VARIANCE REQUEST
Iowa Department of Natural Resources

1. Date: 7/17/14 2. Reviewer/Engr.: Jim Oppelt 3. Date Received: 7/16/14 4. Facility Name: Gilbertville WWTF 5. Facility Number: 6-07-33-0-01 6. County Number: 7 7. Program Area: CP (Wastewater Construction) 8. Facility Type: C04 (Physical Treatment) 9. Subject Area: 369 (Bypass Channel Screen) 10. Rule Reference: 567-64.2(9)a 11. Design Std. Ref.: 15.2.4.2.4 12. Consulting Engr.: SEH 13. Variance Rule: 567-64.2(9)c	14a. Decision: <i>Approved</i> Date: <i>7-18-14</i> Expiration Date 14b. (if any): Permanent 15. Appealed: Date:

RE: Wastewater Treatment Improvements
City of Gilbertville
DNR Project No. S2009-0110
CWSRF No. CS1920548 01

Subject: Variance Request from 567 IAC 64.2(9a) and Design Standards Section 15.2.4.2.4.

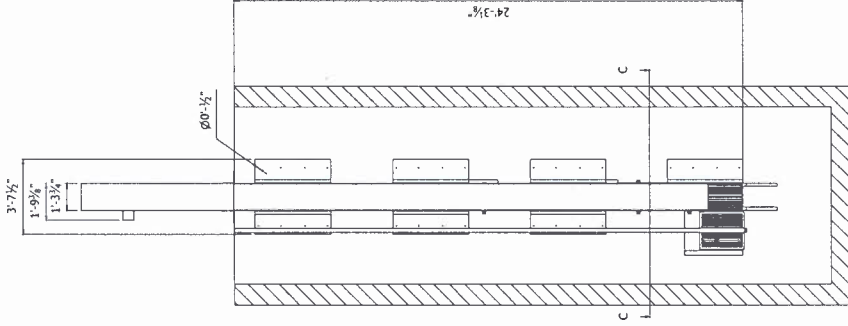
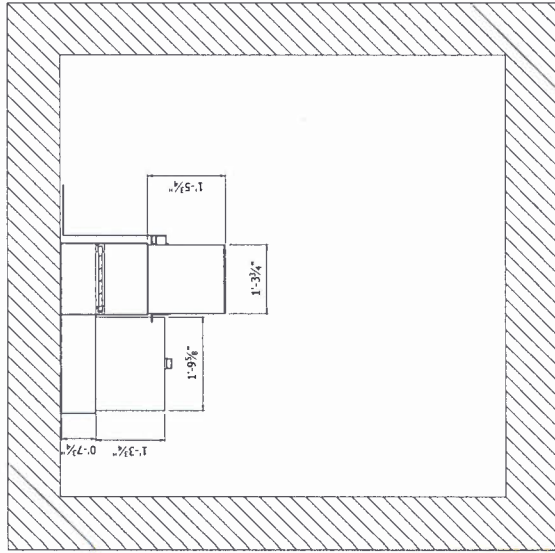
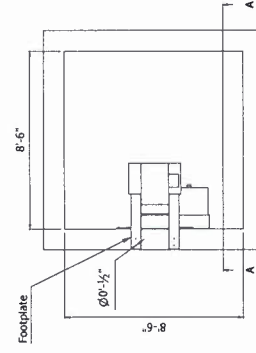
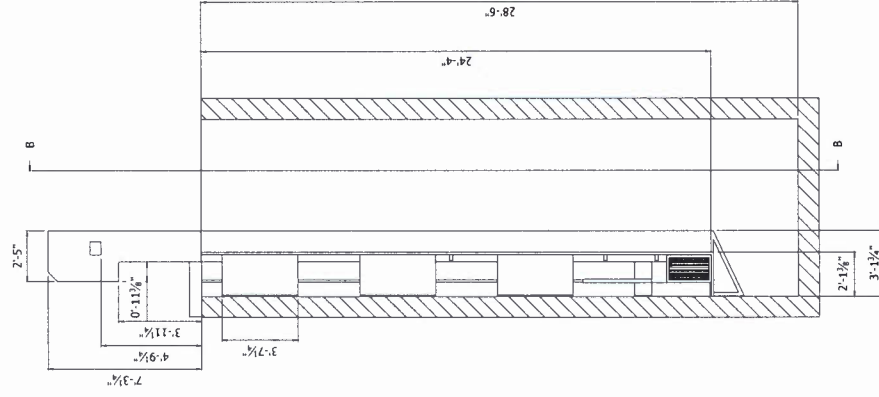
On sheet 2 you can see that the screen has been modified to be mounted on a guide rail. We have added a slide gate that will shut off flow to the primary screen and divert it to the bypass screening basket, which is mounted to a frame that is independent of the primary screen and cleaning mechanism. This allows for the screen to be removed while still providing screening. In addition, should the primary screen ever become clogged, the influent can only backup to the elevation of the bypass weir before it automatically begins to flow into the bypass screening basket. The primary screen is designed to pass 100% of PHWW flow even if it becomes 50% blinded.

The bypass screening basket is designed to be raised and lowered manually for cleaning.
